## **MINE DEVELOPMENT CERTIFICATE**

### **MINE DEVELOPMENT CERTIFICATE 92-13**

## **Ministry of Energy and Mines Role and Response**

# Panel - Stage 6B Geometry

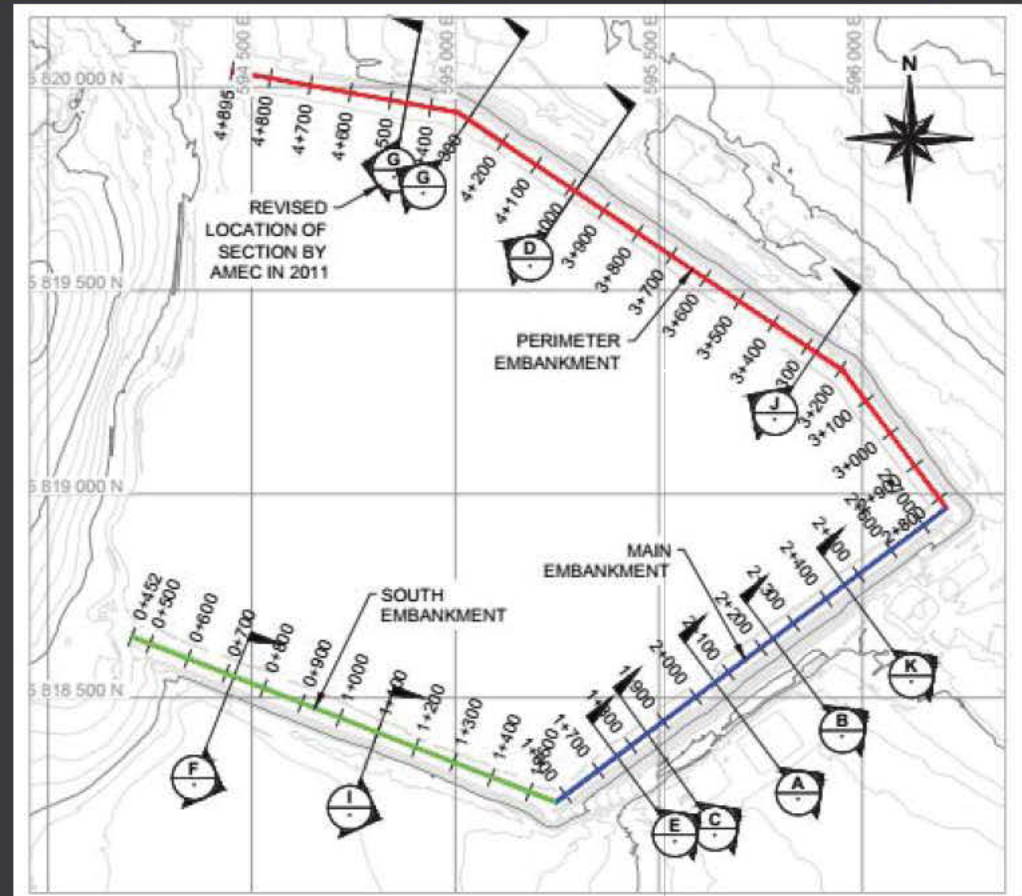
- Panel extrapolated geometry from Section 1/Plane D at Ch. 39+86 instead of Plane G at Ch. 43+00
- Panel assumed angle of repose embankment slopes incorporated in Stage 6 and subsequent stages

# 2010 Ortho at Plane G

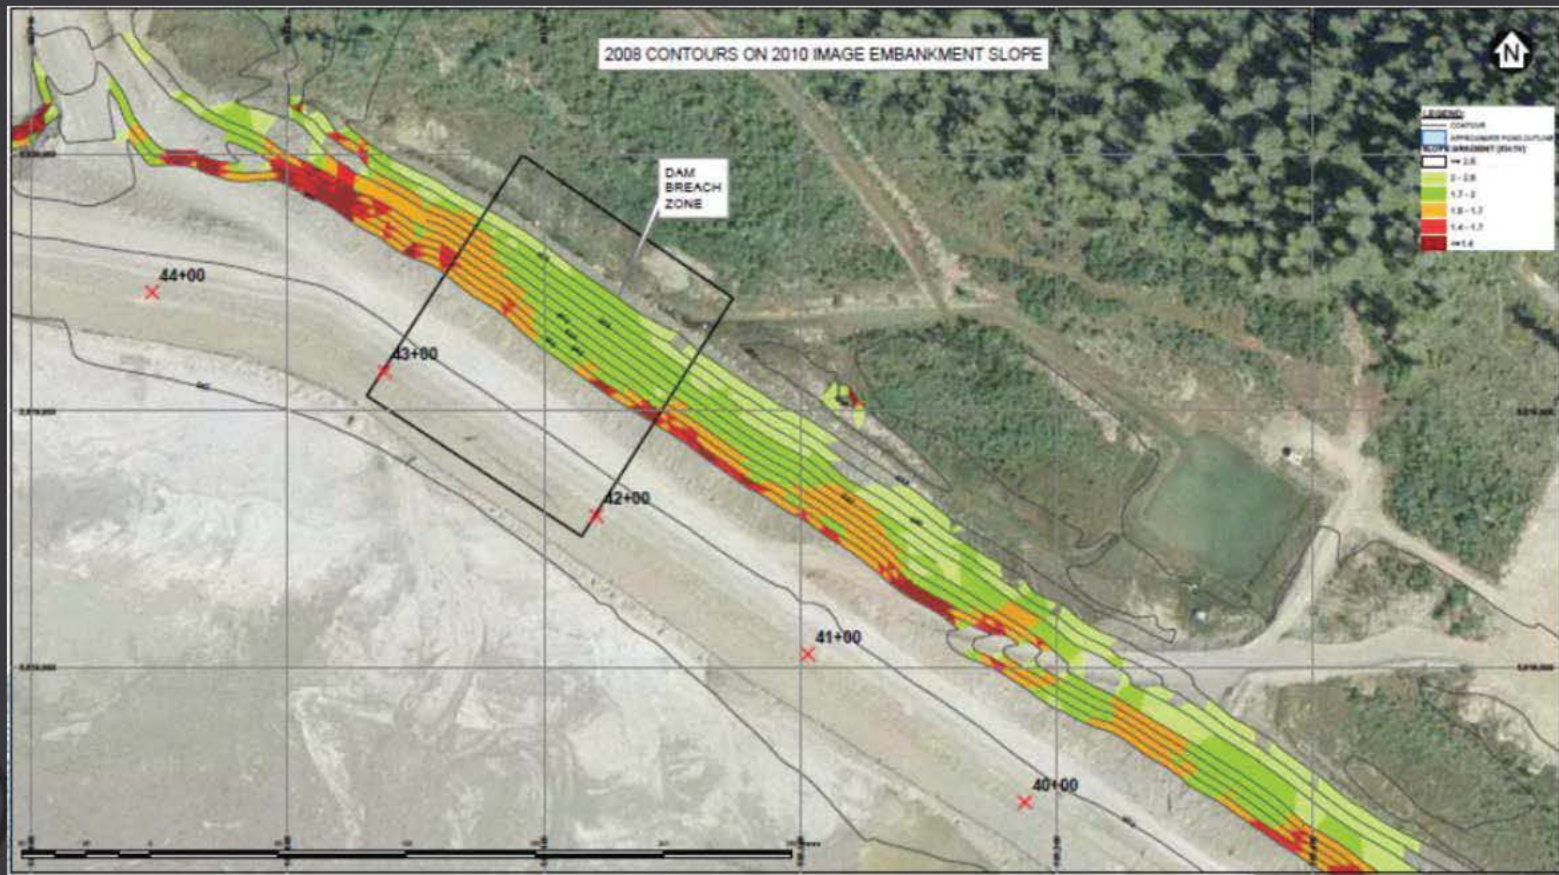
~52m

Slope ~1.9H:1V

# Panel - Compacted Rockfill Layering

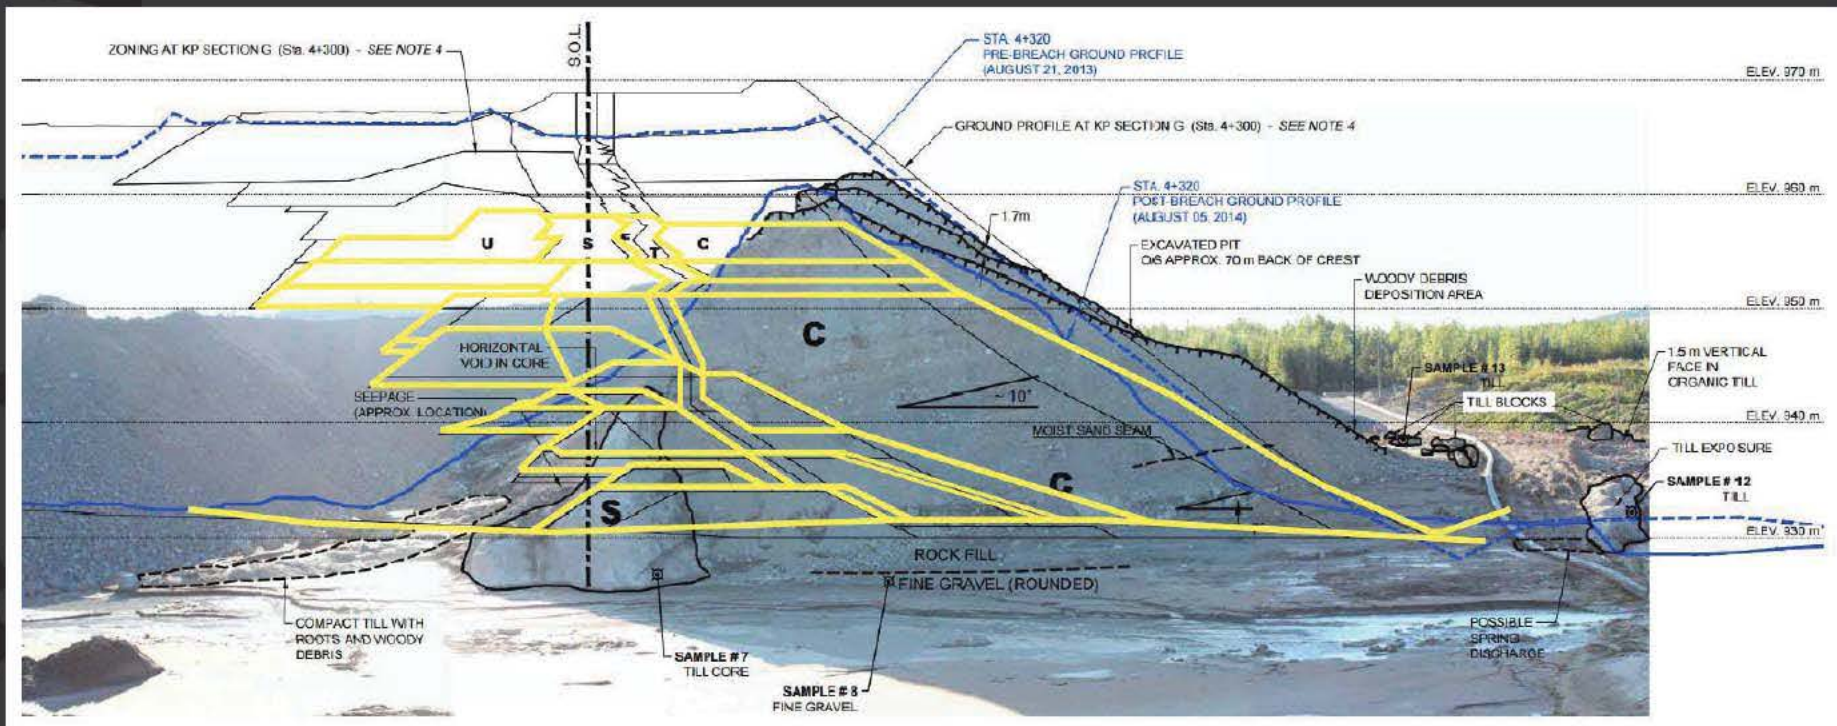
- Left Abutment Field Mapping Notes and Zoning at KP Section (Sta 4+300) (Figure C5) vs. Stage 6B As-Built
- Fill layering confirms flatter Stage 6B geometry rather than angle of repose slope
- Illustrates “bottom up” construction in compacted lifts up to Stage 6B

# Top Down End Dump

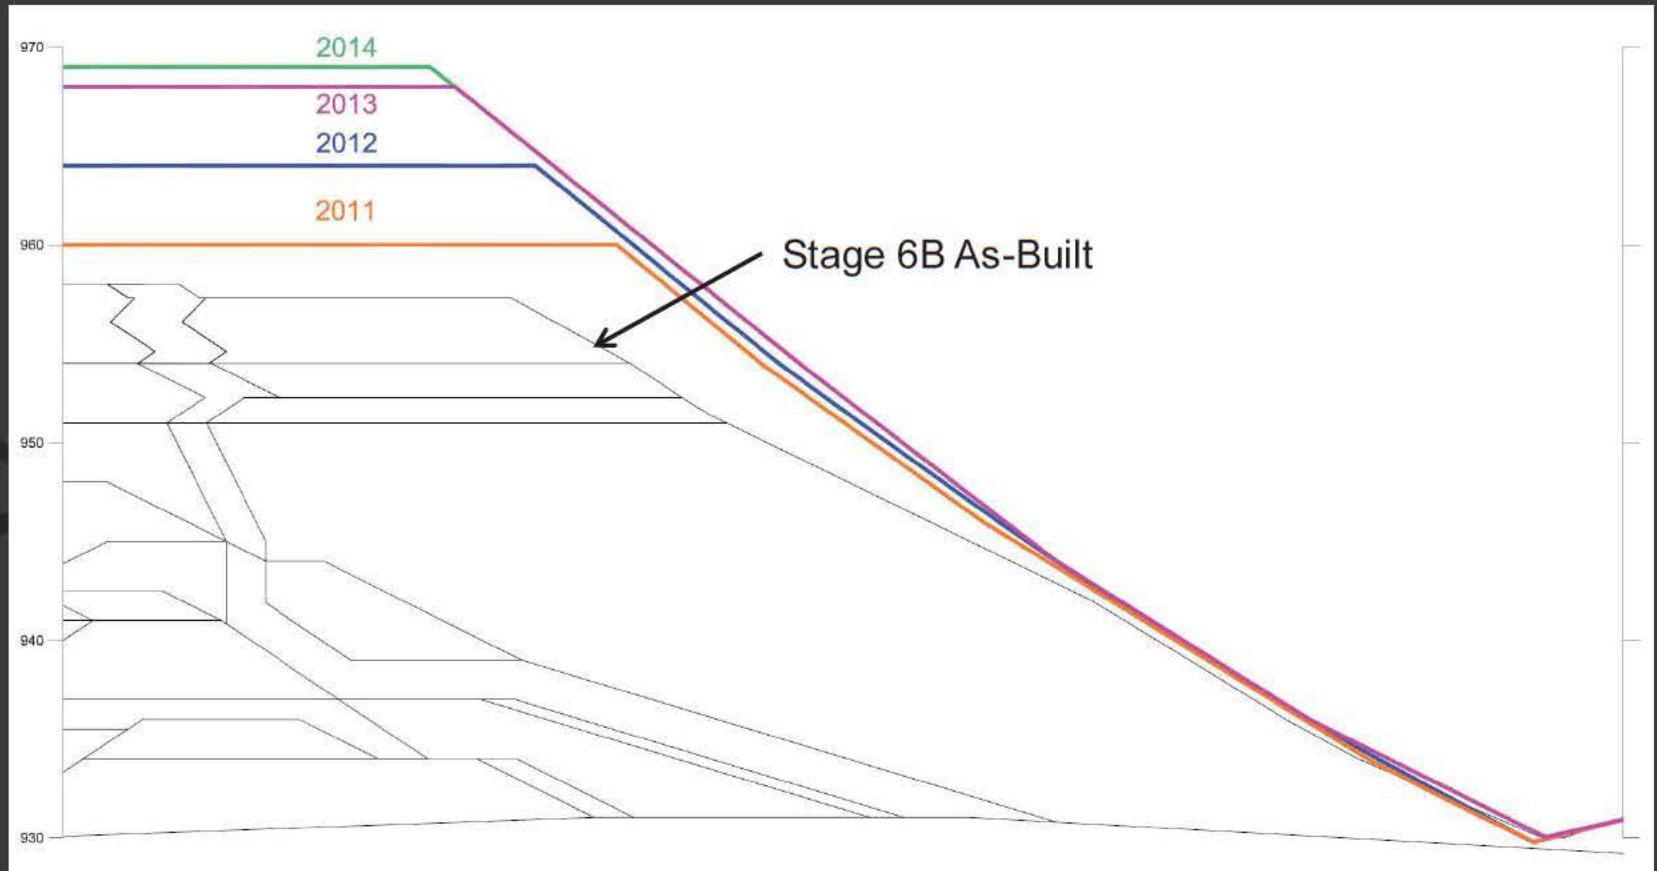
- Simplified sections generated from the 2011, 2012 and 2013 topography (backup information from the Panel report) and from the Panel's stability analysis (2014)
- Angle of Repose slopes developed using "top down" end dumping after Stage 6 (after 2010)

# Panel Stability Section vs Stage 6B As-Built

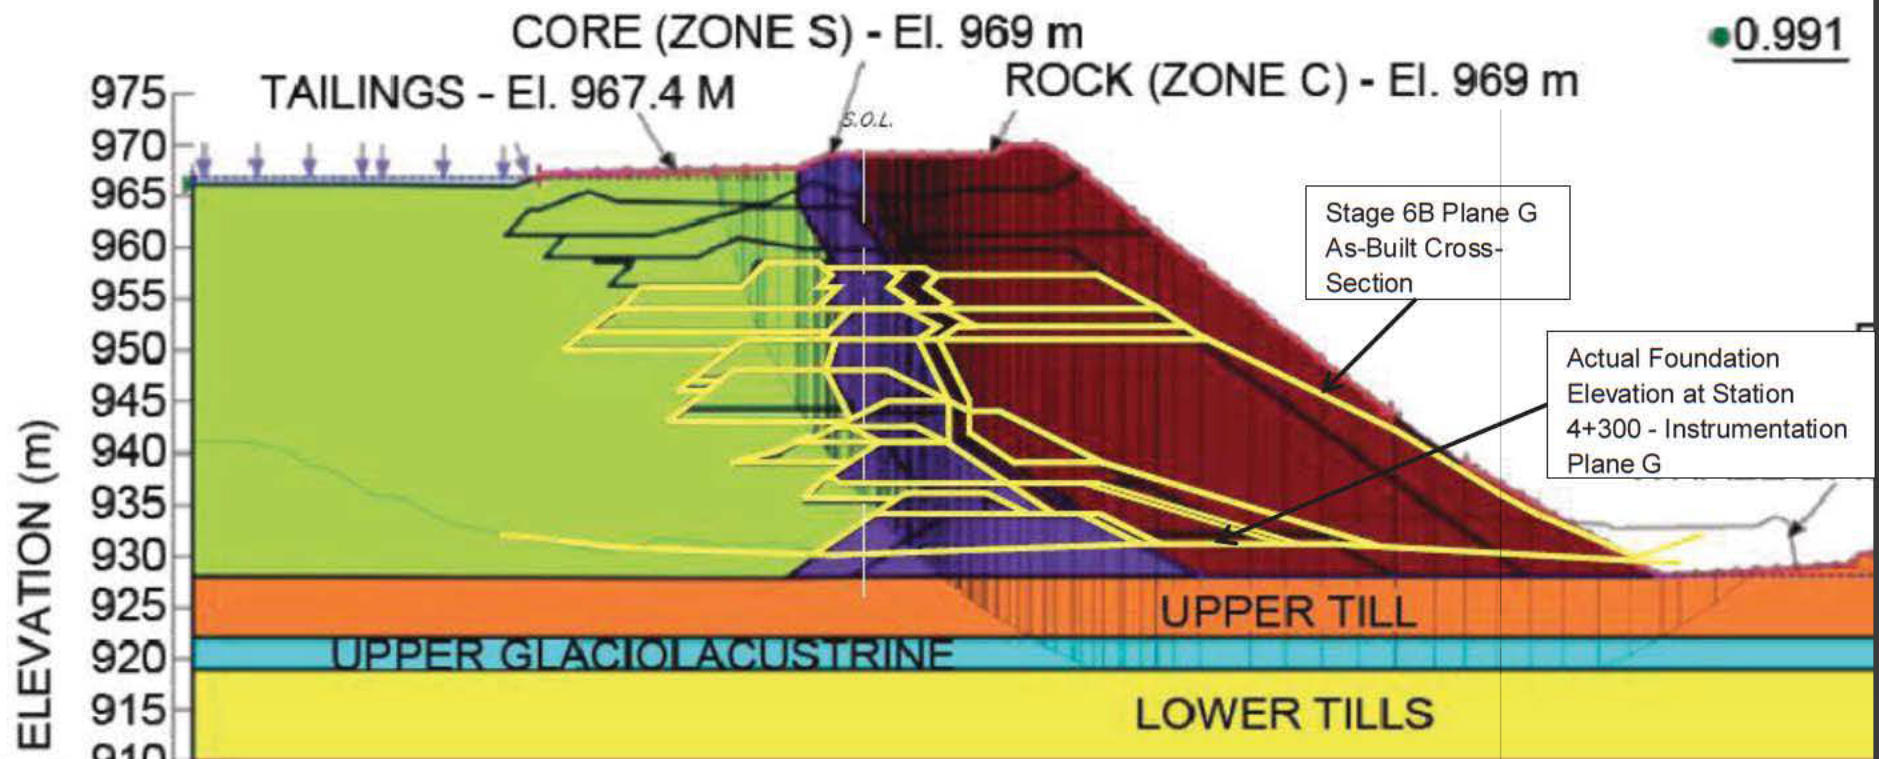
- Yellow outline shows actual geometry superimposed on Panel geometry
- Internal staging used by Panel is incorrect

## Corrective Action:

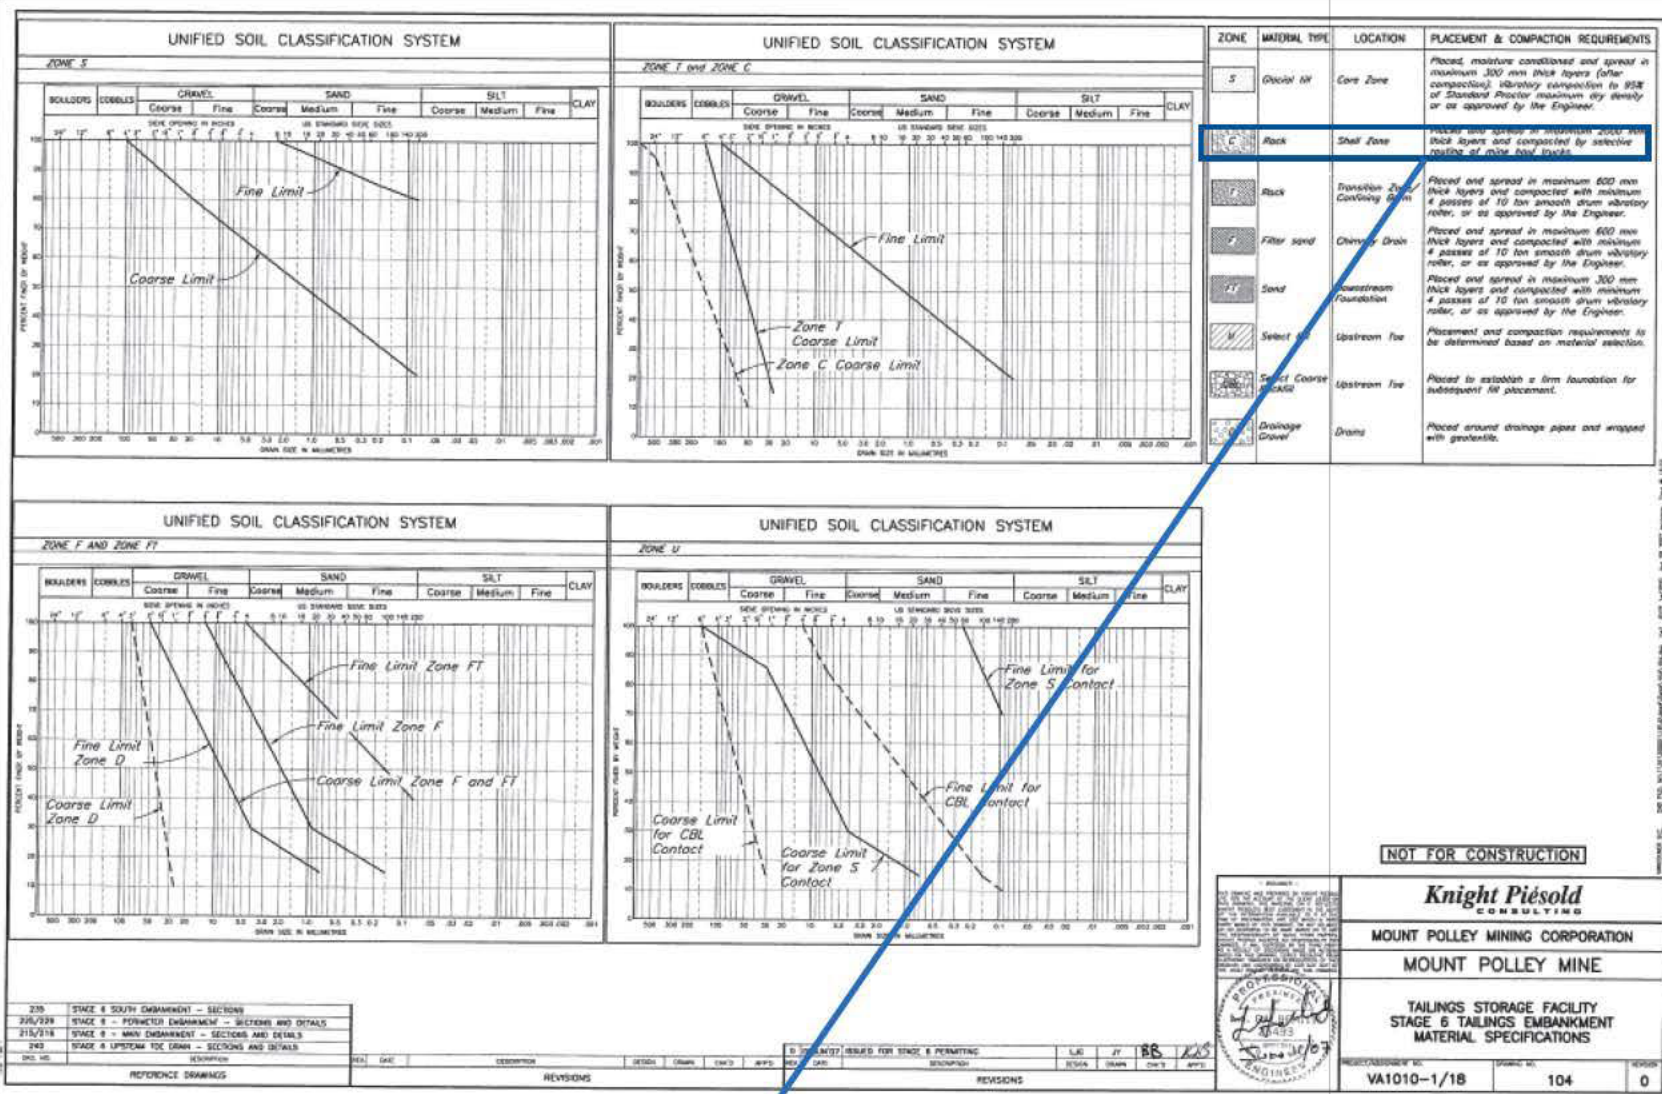
Short of issuing errata to the Panel Report, it is important that the investigation under the Chief Inspector acknowledge discrepancies between the findings in its investigative report (expected in June) and the Panel Report (both conducted under MEM) to ensure that incorrect and unfair aspersions against KP are lifted
